CHINO BASIN WATERMASTER

Ground-Level Monitoring Committee

SUBJECT: *1D Model Simulation of Subsidence in Northwest MZ-1—Subsidence Management Alternative #1 (FINAL)*

APPENDIX A – RESPONSES TO GLMC COMMENTS24

Figure 13. Northwest MZ-1 Guidance Level versus Projected Heads and Modeled Compaction at PX under SMA-1

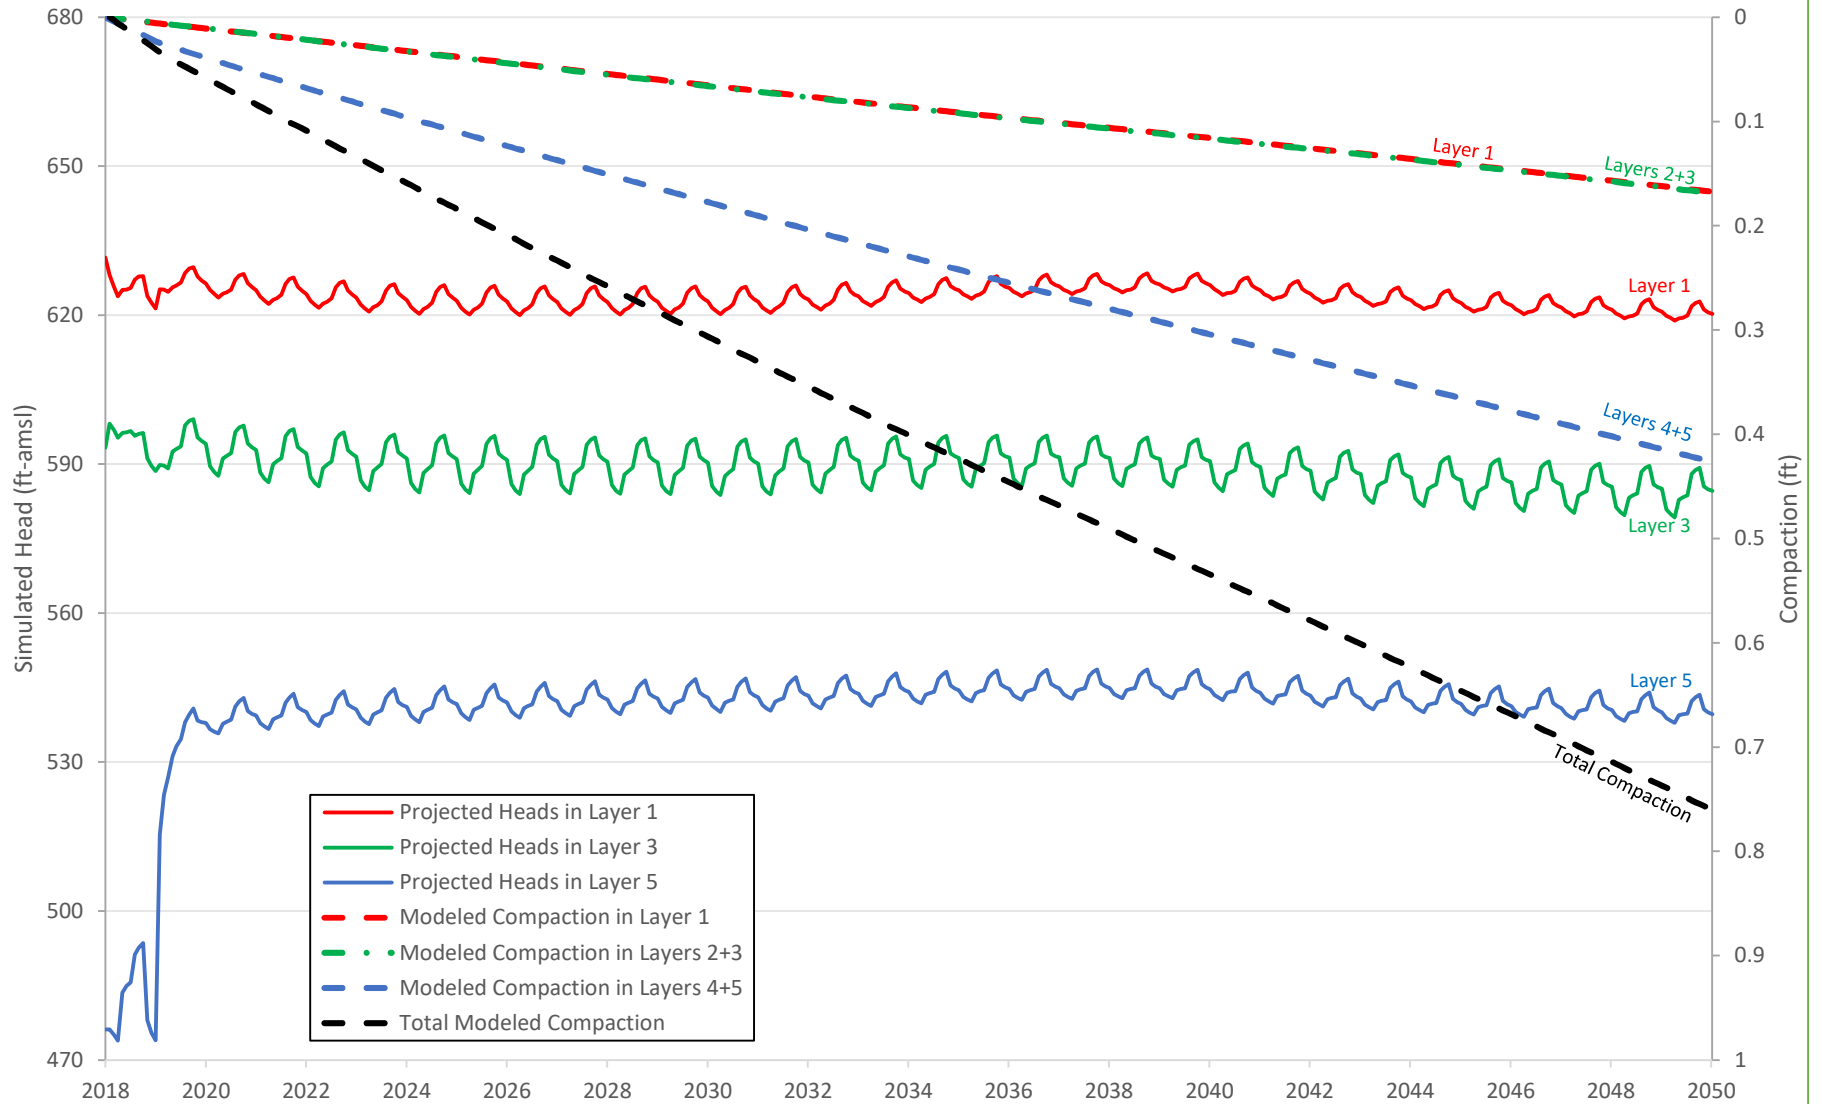
Comment 15 – Figures 13

We recommend removing this figure until additional analysis is conducted as discussed in comments regarding Conclusions and Recommendation?

Response:

This figure should remain to illustrate the “preliminary” Guidance Level.
